RE: Administrative Order On Consent
(Dated November 27, 1990)
Franklin Power Products/Amphenol
IND 044 587 848

The United States Environmental Protection Agency (U.S. EPA) has determined that the reports titled "Report of a Corrective Measures Studies for the Former Amphenol Facility, Franklin, Indiana", as revised September, 1995, and "Report of Additional Corrective Measures Studies for the Former Amphenol Facility, Franklin, Indiana", as revised November, 1996, which constitute the Corrective Measures Study (CMS) report for the above referenced facility, are acceptable for public review and comment. In addition, U.S. EPA has reviewed the supplemental report for the RCRA Facility Investigation (RFI) "Report of Shallow Groundwater Sampling Along Hurricane Creek, Former Amphenol Facility, Franklin Indiana", dated November, 1996, and hereby approves this report.

Attached, please find four bound copies of a *Report of Additional Corrective Measures Studies for the Former Amphenol Facility, Franklin, Indiana* submitted on behalf of Respondents Amphenol Corporation and Franklin Power Products. The report was revised in accordance with your September 12, 1996 comment letter received b

CURTIS - FRANKLIN
FRANKLIN, INDIANA
FORMER AMPHENOL CMS
SITE MAP

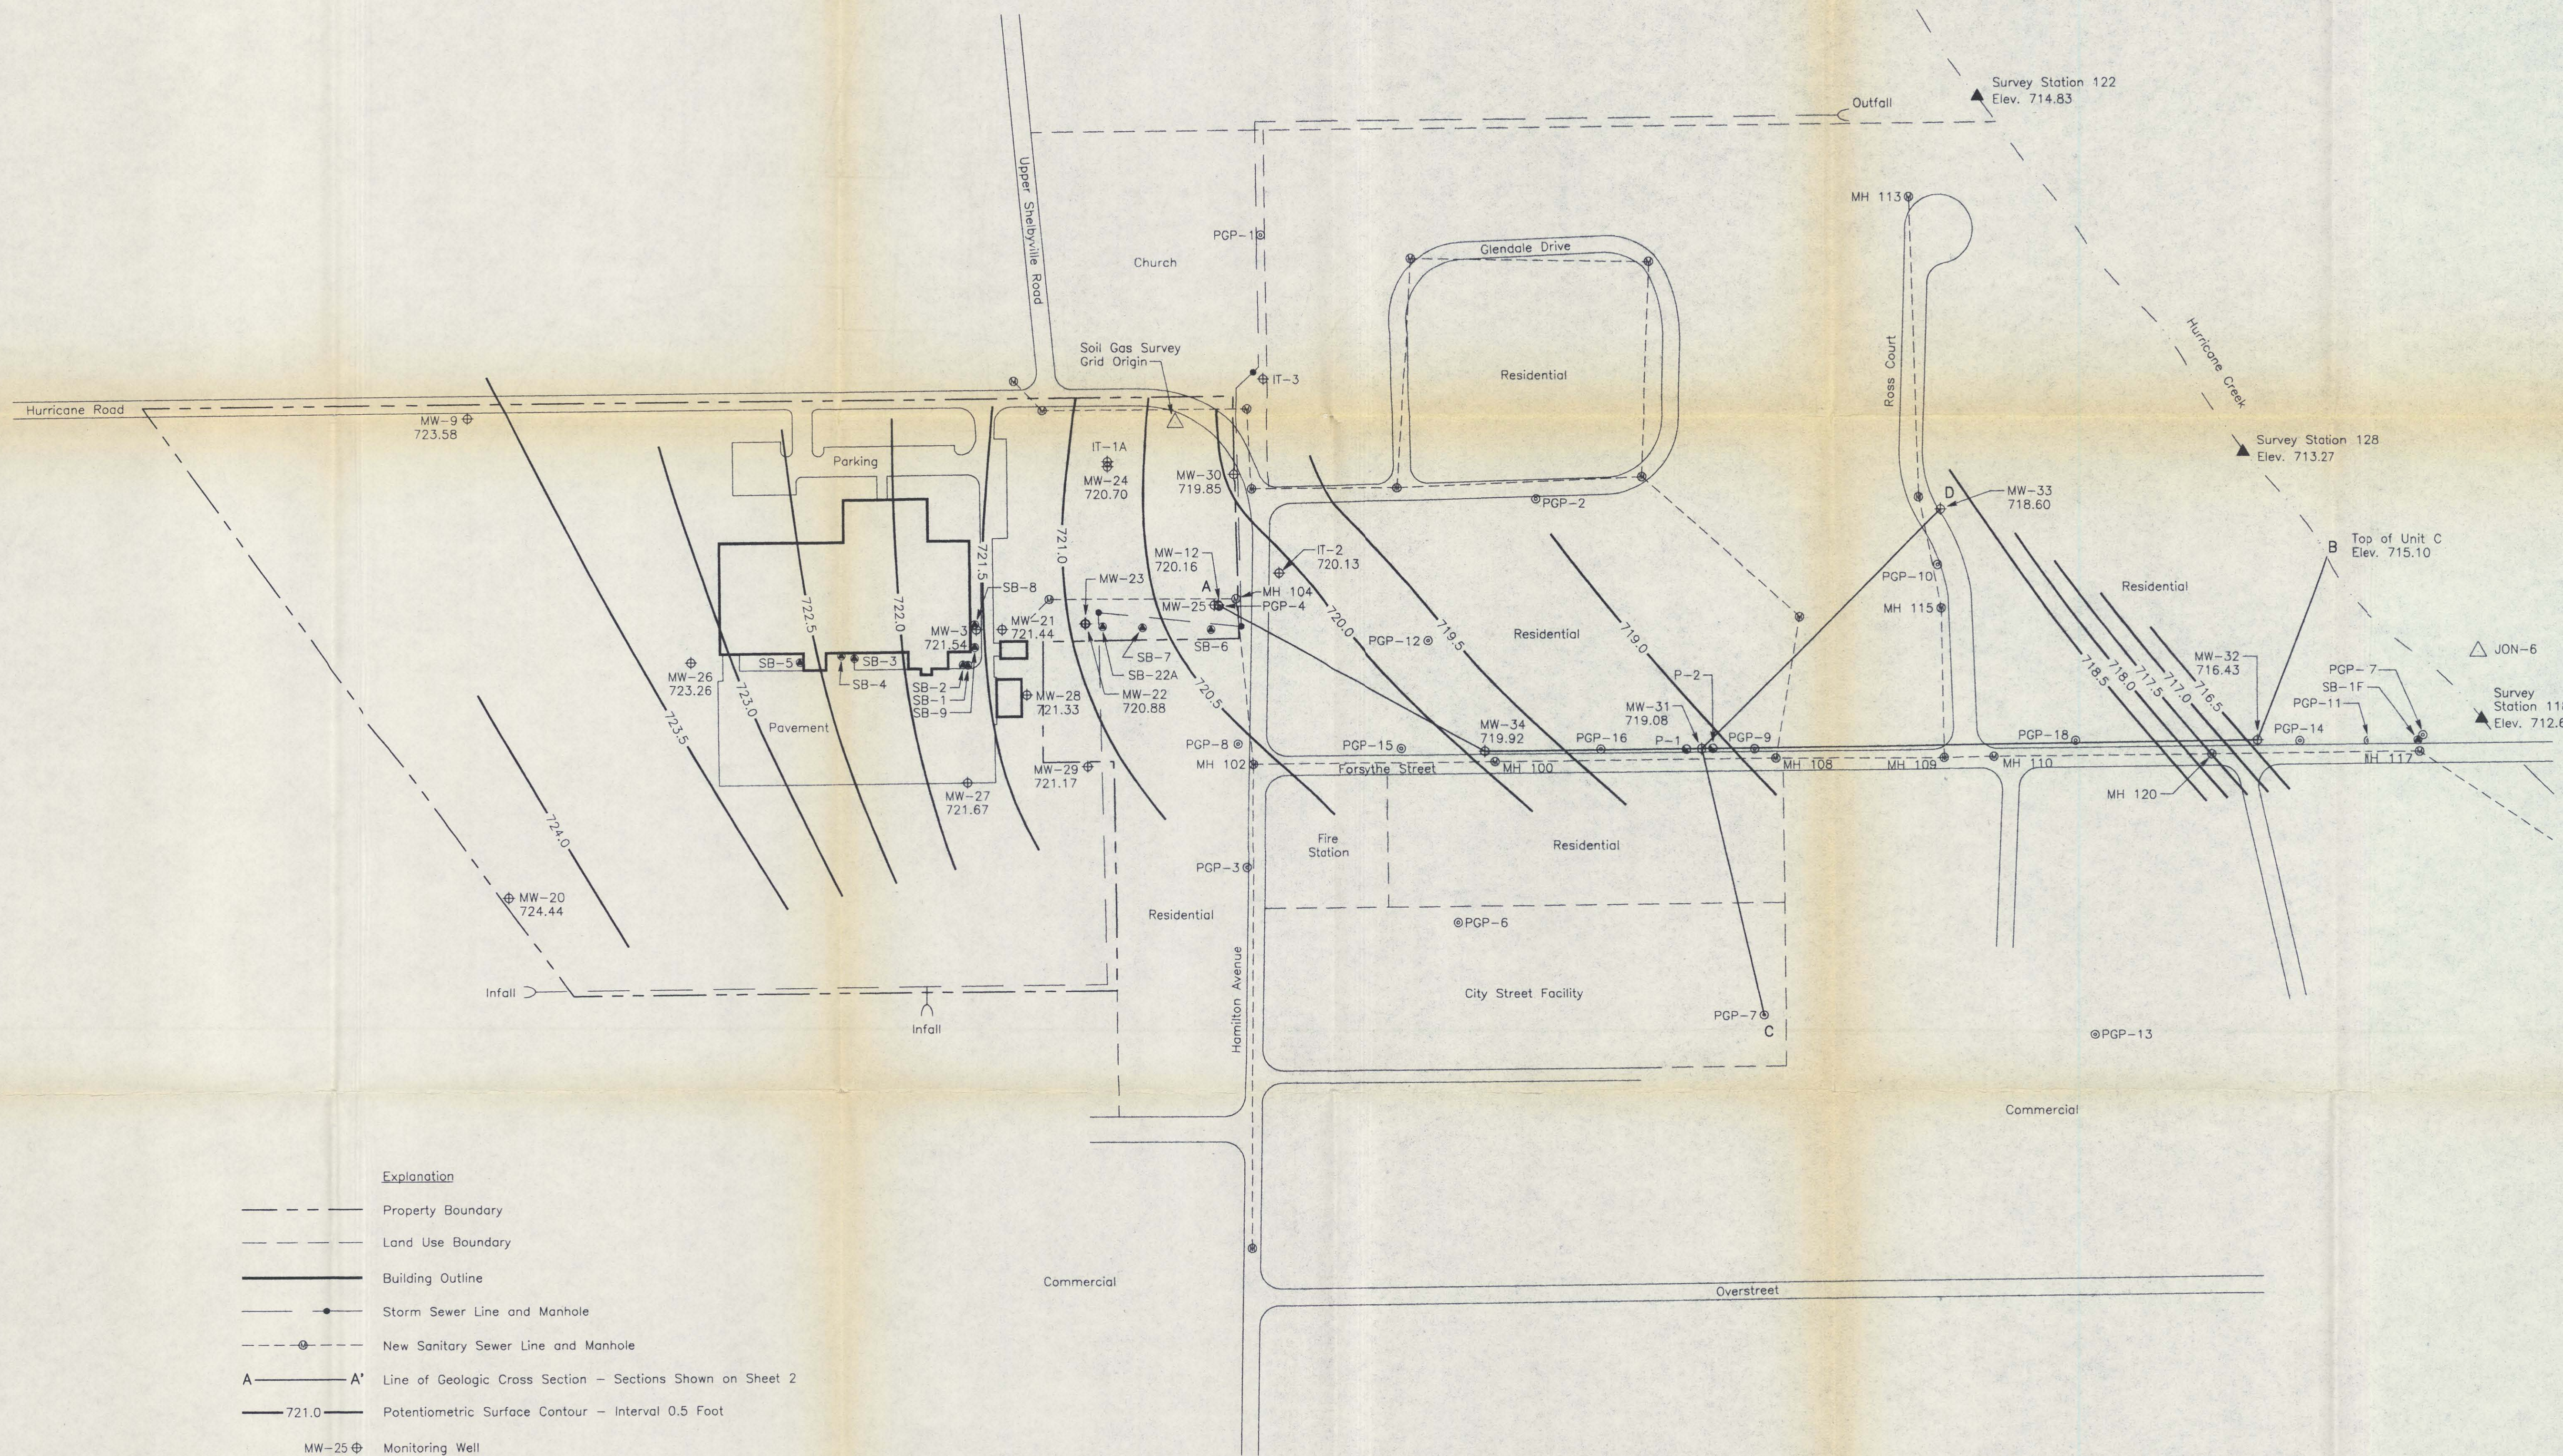
2. The groundwater contour levels in sheet 1 do not correspond to the water level data of wells MW31, MW32, and MW33. These data indicate that groundwater flow direction at the time of measurement was to the southwest at this location. This flow direction is significantly different than the southeastern direction shown. The figure should be revised to show water level contours that correspond to the data.

General Comment 2. Sheet 1 was not revised, but Section 3.1.3 of the revised text discusses alternate interpretations of ground water flow direction south of MW-31 and Ross Court.
